Application No.: Not Yet Assigned
Preliminary Amendment

Amendments to the Drawings:

BROADBAND MICROWAVE POWER SENSOR

FIG. 4

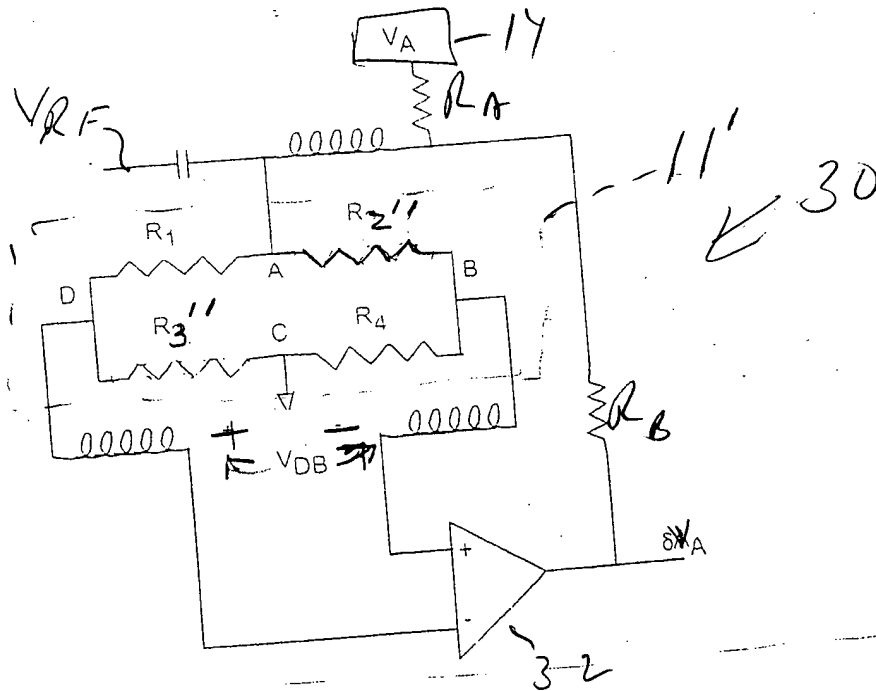
The attached sheet of drawings includes changes to Fig. 4A and Fig. 4B. This sheet, which includes Fig. 3 and Fig. 4, replaces the original sheet that included Fig. 3, Fig. 4A and Fig. 4B.

Formal drawings have not been filed in the above-identified patent application. Applicant requests approval of the change as shown on the attached marked-up drawing sheet.
